REQUEST FOR PROPOSALS

Removal/Replacement of Diesel Fuel Storage Tanks

DULUTH TRANSIT AUTHORITY

Addendum #3

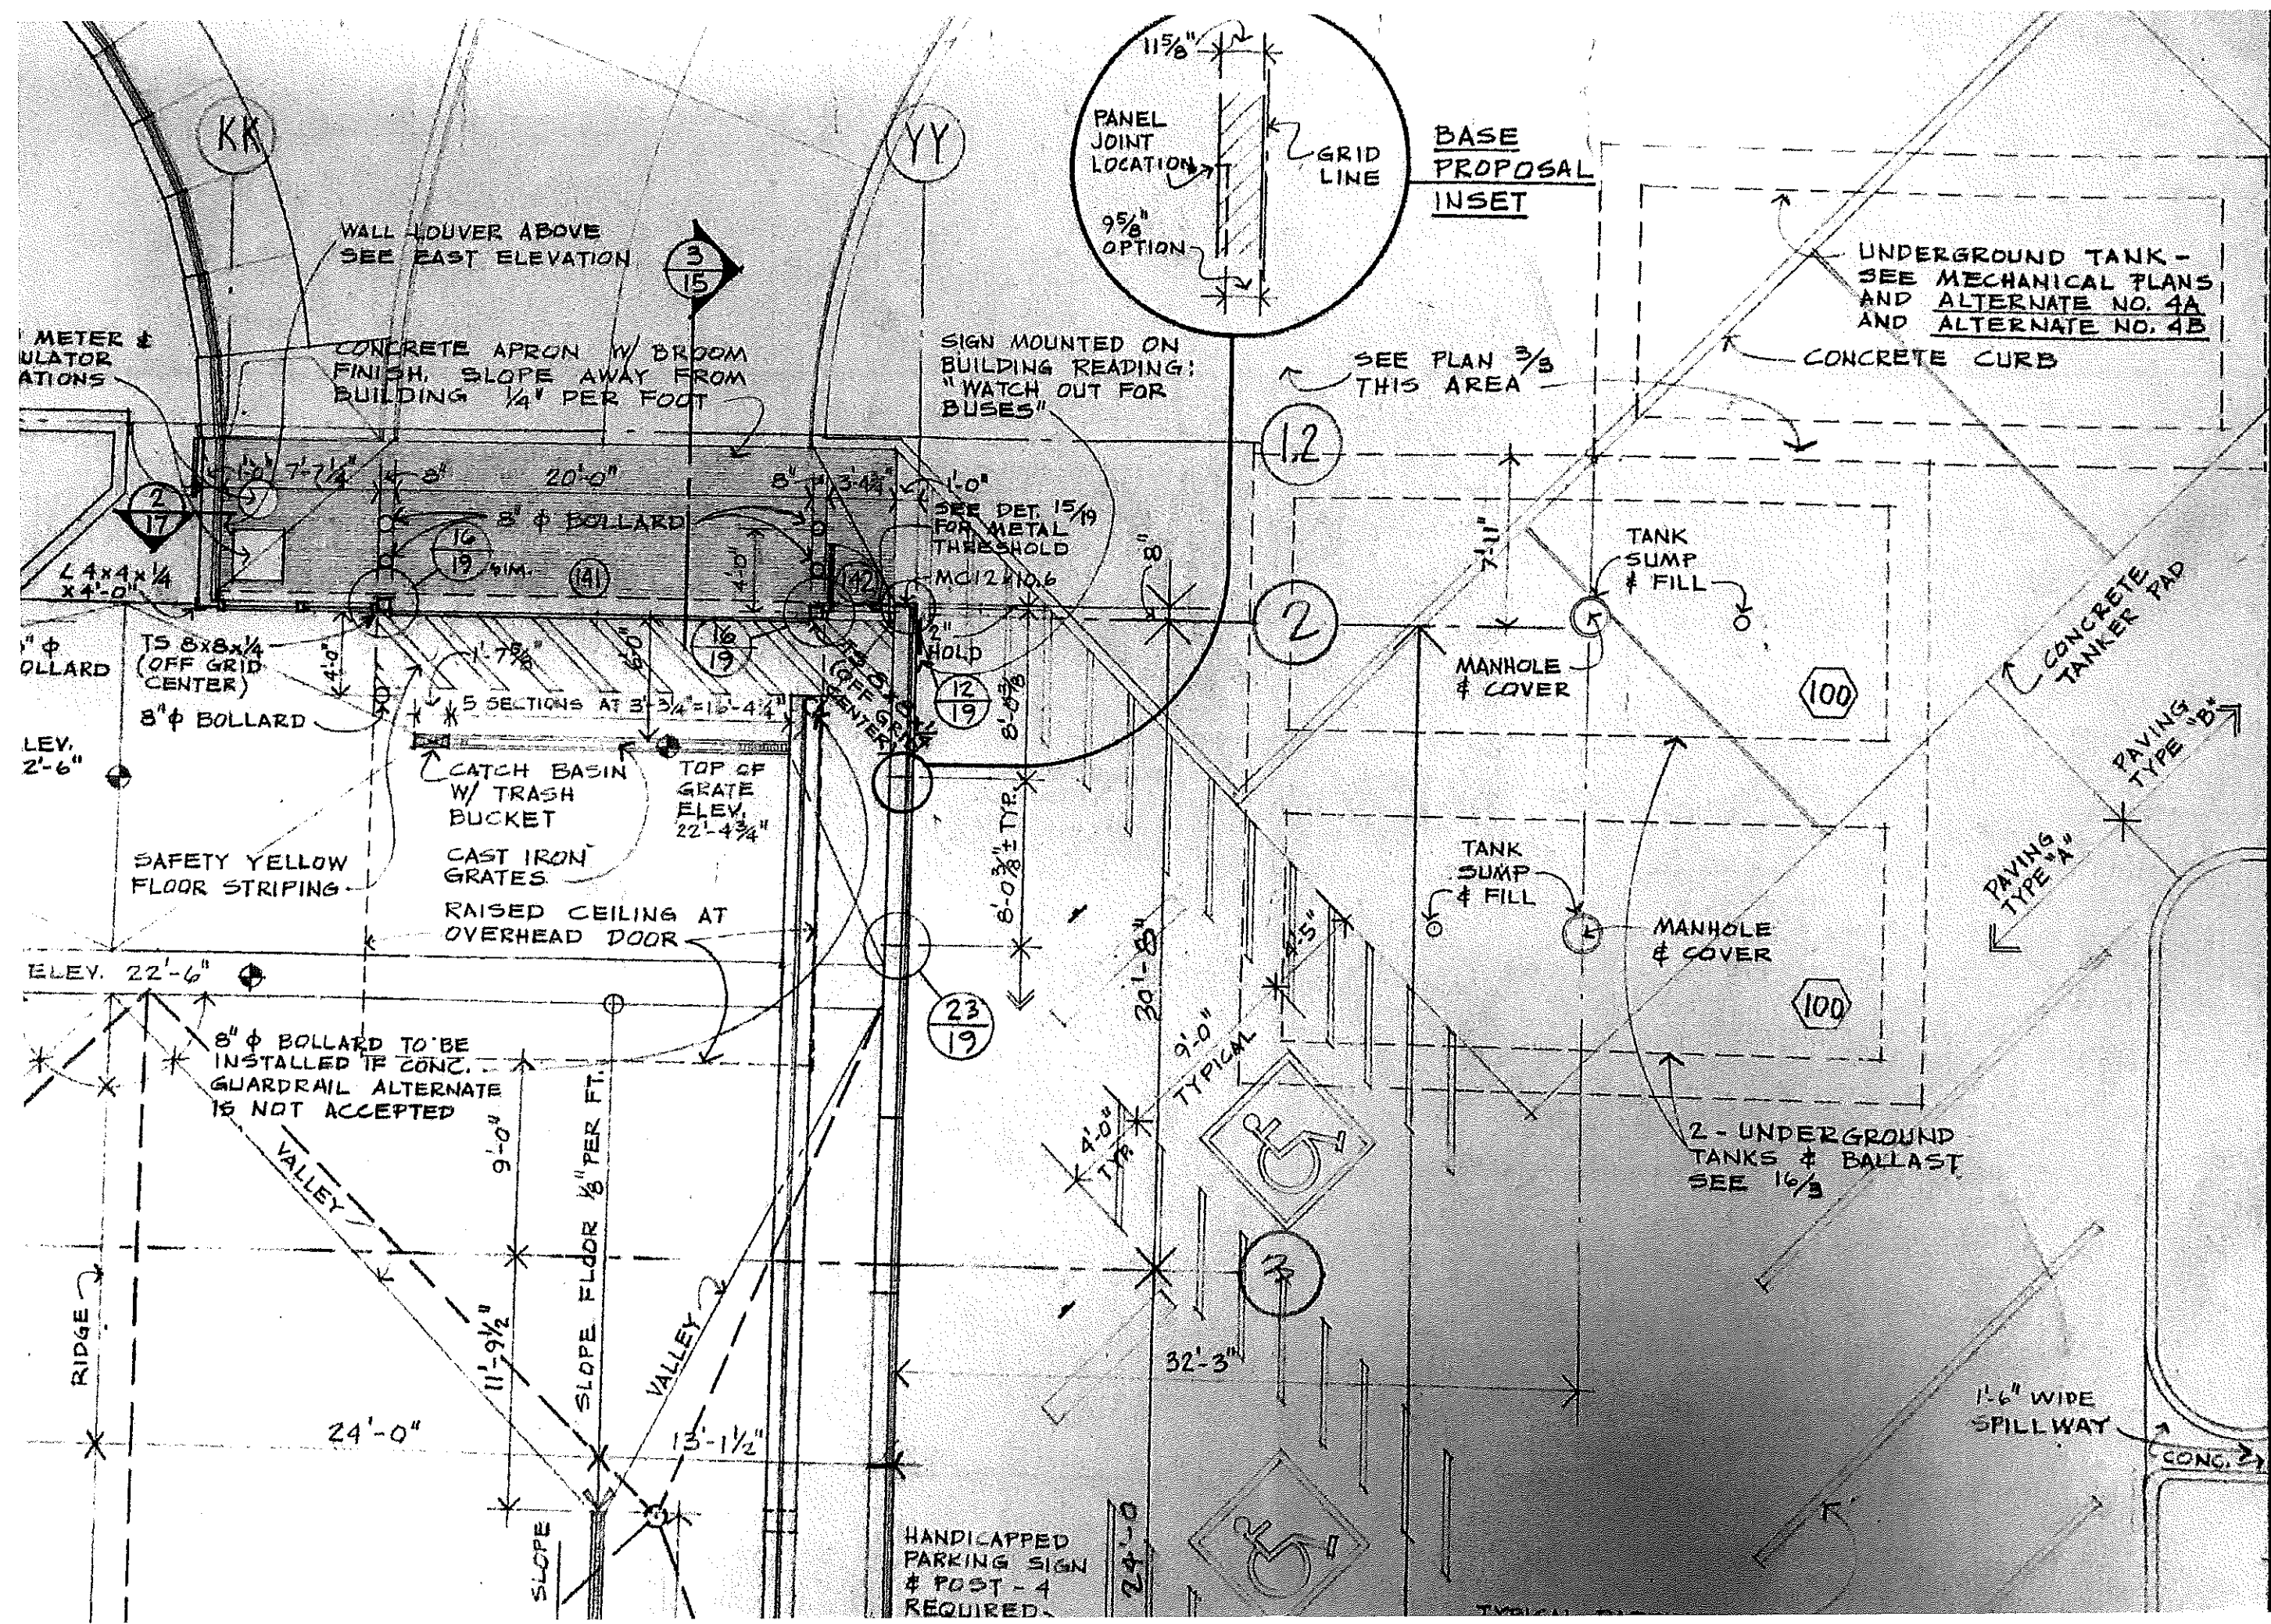
10. More drawings of the area where the USTs are currently is attached. These drawings are not to scale, and may not be used to determine current conditions. They are for informational purposes only.
